KMR.CDD.RaQ.1920.01

KMR.CDD.RaQ.1920.01
No. CDC 936 of 1920,
Revenue Department,
City Deputy Collector's Office,
Karachi. 13th July 1920.

AMENDED
PLAN SHOWING PROPOSED BUILDING
ON PORTION OF PLOT N^o 107 E.G.
RAMSWAMY QUARTER
SCALE 4 FEET TO 1" INCH

I beg to inform you that I intend building The Proposed building
to be built on portion of plot No. 107
Survey Sheet No. E. 6 situate in Ram Swami quarters
Street, Jewan Quarter.

Dix

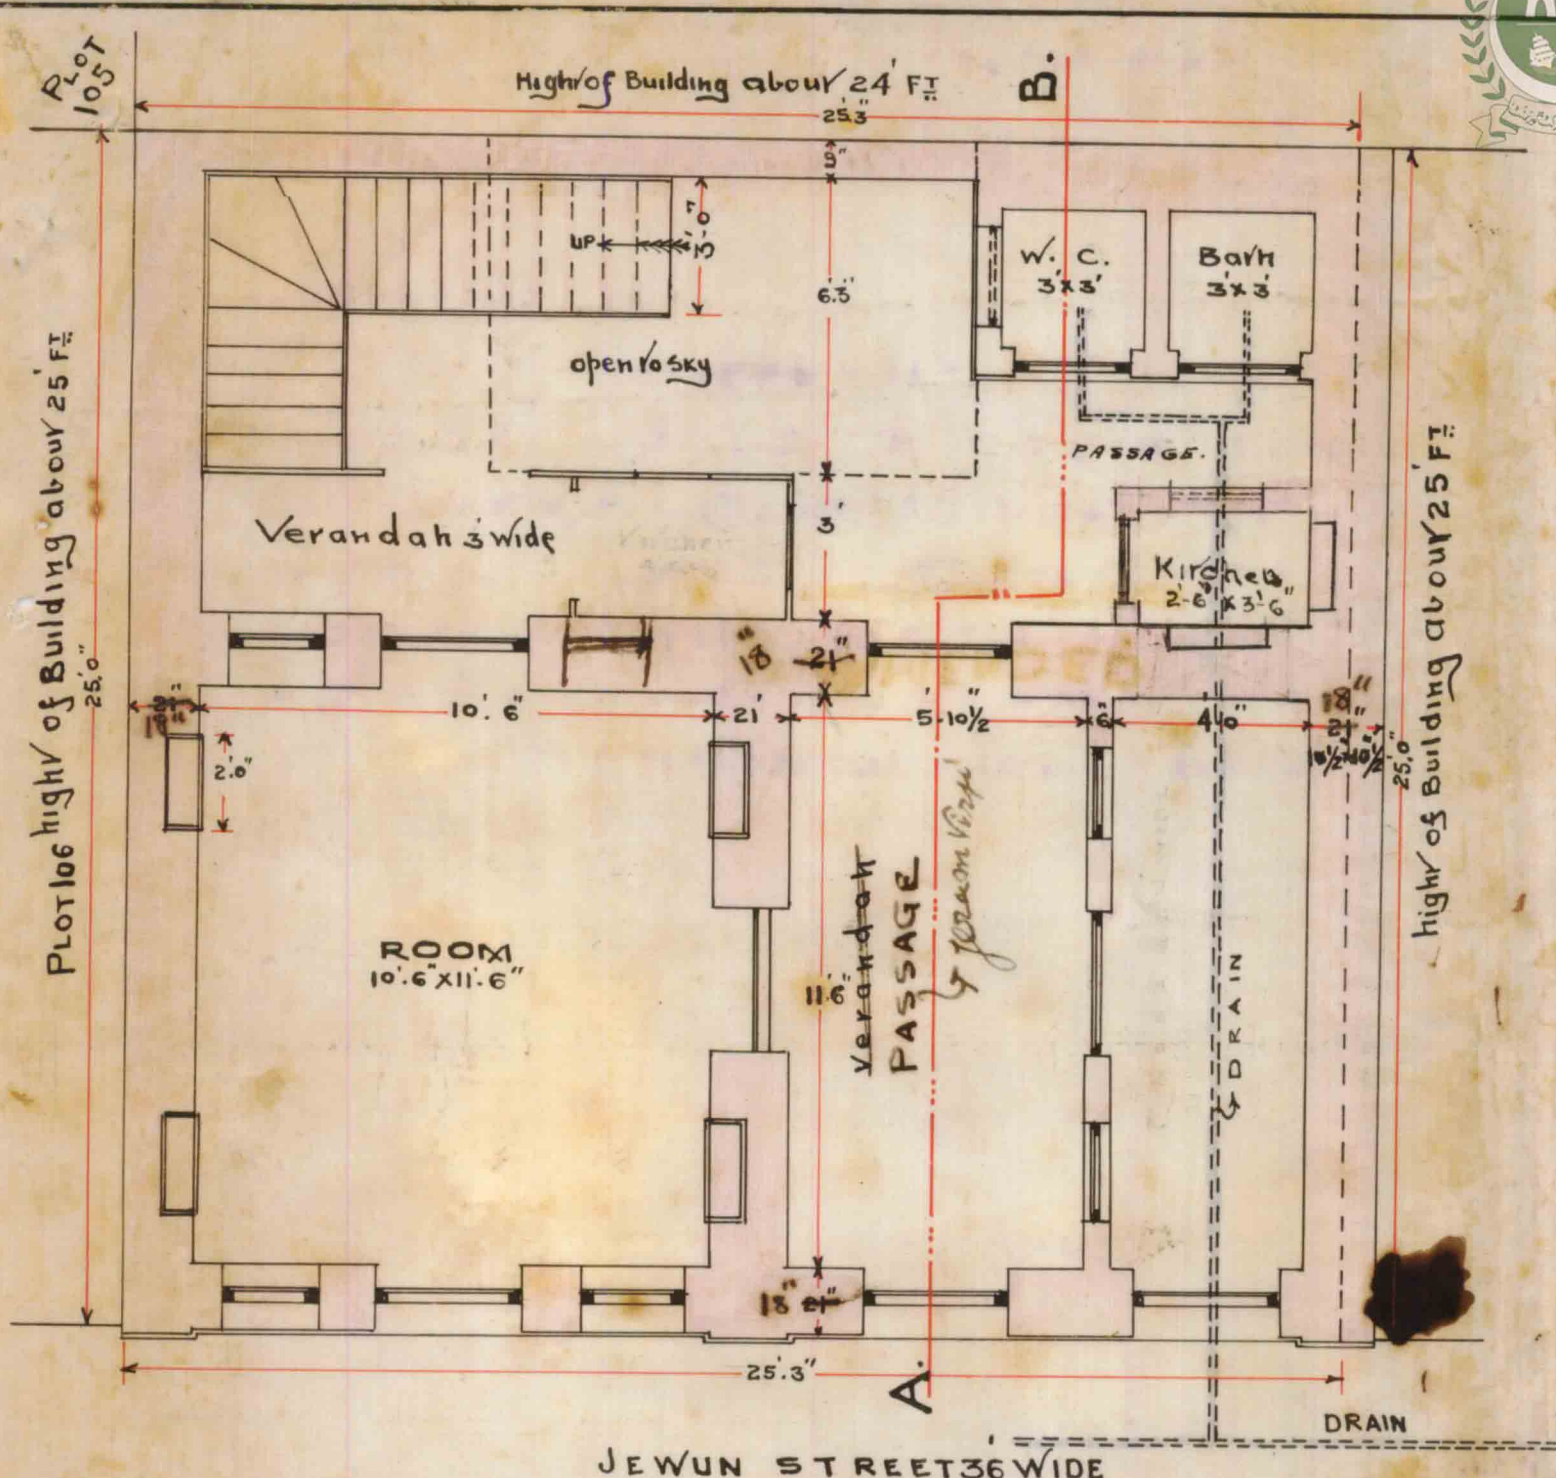
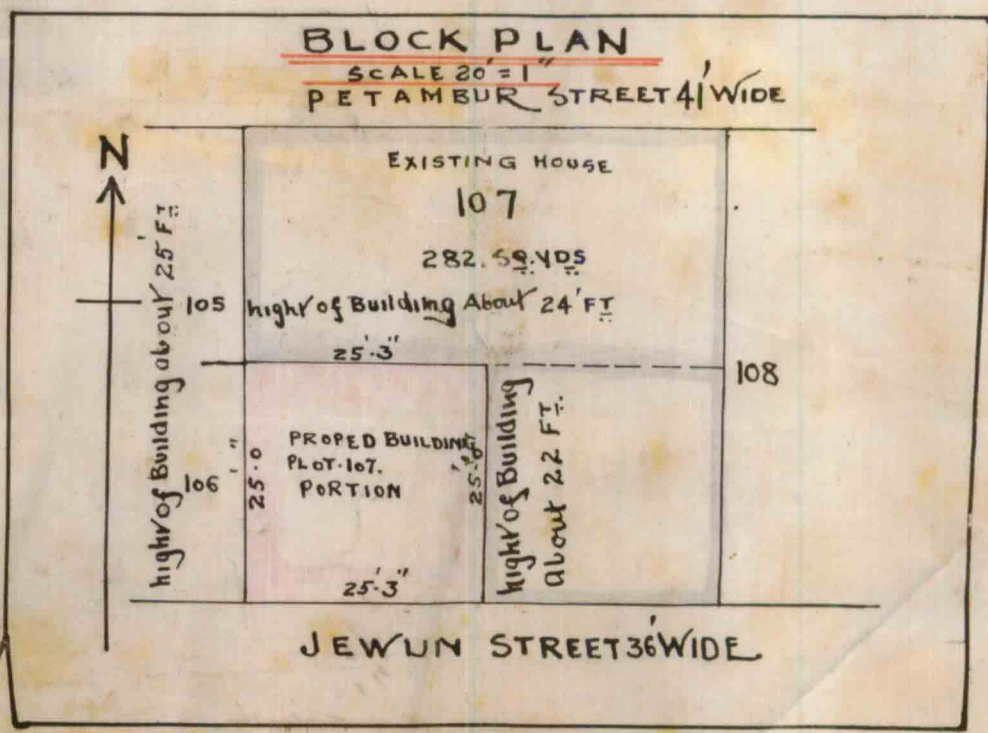
With reference to his application dated 30th ultimo, with a plan for the proposed building on portion of plot No:107. Sheet E-6 Ramswami quarter Mr Jeram Virji is informed that permission to build a four storied building on a small portion of the plot will not be permitted. One floor must be deleted.

SirWith reference to the Rep Report thatthickness of walls must be kept 21", 18", 18" & 15"instead of 21", 18", 15" & 14" & width of foundationincreased to 10'0".

Remarks Sir, With reference to his letter to report
that the plot should be subdivided before
it can be approved. That it is not advisable
to allow the building to be erected on such
a small plot. Open space should be reserved

Permission to build a four storied building
on a small portion of the plot will not
be permitted. 1.21/5/20

With reference to his application dated the 2nd November 1920, requesting permission to build on a portion of plot No. 107 (Sheet E-6) Ramswamy Quarter, in accordance with plan No. 274 approved by the Engineer, Karachi Municipality, Seth Jeram Virji is informed that the above plans can not be sanctioned until an access is provided to the open yard.

With reference to this I beg
to report one floor has been
deleted. There is no objection
in issuing permission.

Regarding your no L.S. 2929 Dtd. 28th May, I herewith enclose the plan of the proposed building on plot no. 107 Sheet E.6. *Ran...* *quarrel*, altered as suggested by you. *...ing an early ...*

Submitted with report, the plan has been amended in the light of C.D.C. remarks. There will be now no objections to issue plan after hearing from the C.D.C.
